IFB No. **23-17 Administration Building 2nd Floor Renovation**

RE: **ADDENDUM NO. 2**

PROJECT: RPS 205 ADMINISTRATION BUILDING
2ND FLOOR RENOVATION
ROCKFORD, ILLINOIS

L&D PROJECT NO.: 31225

DATE: 07-28-2022	PROJECT NUMBER:
31225	SHEET NUMBER:
FPI.1

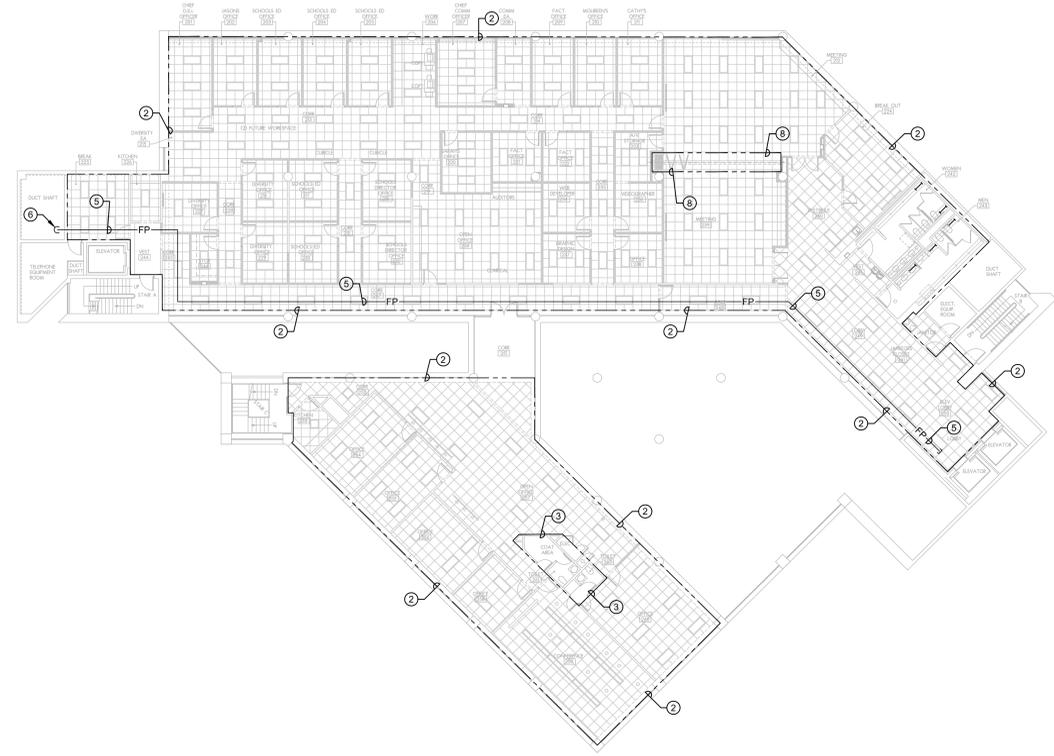
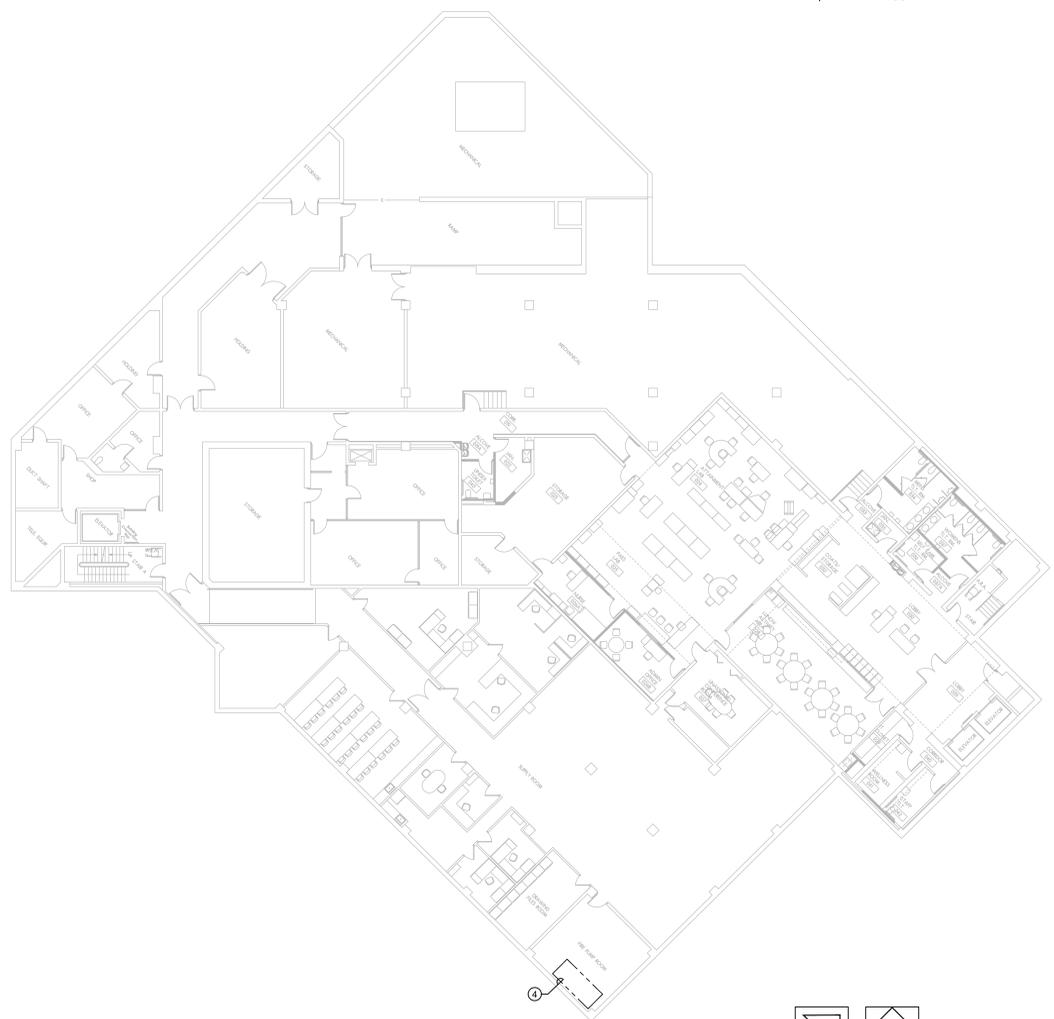
- A. *According to the specs it says we need to calculate the whole building? This is an existing system with fire pump, is that required? I plan on us calculating the 2nd floor only, because it is around 170 heads to relocate. Please advise if no calcs are needed. We will only supply a head layout with hydra calcs, and not a complete working drawing for all the existing pipe that is up there already. Beings this is an existing system and we are not planning on relocating any mains or branch lines this shouldn't be a problem.* **CS2 Response: Only the area indicated on the second floor needs to be hydraulically calculated. Sprinkler mains are to remain in current location. Existing sprinkler heads, arm-over piping, and misc. branch piping will be removed in area of work as indicated on the drawings. Drawing FP1.1, General Notes, Drawing Notes and Design Criteria have been modified to address the questions above. Drawing FP2.0, Fire Protection – General Notes have been modified to address the questions above.**

- A. Drawing FP1.1 Revised Drawing: General Notes, Drawing Notes and Design Criteria have been modified.
- B. Drawing FP2.0, Revised Notes: General Notes have been modified.
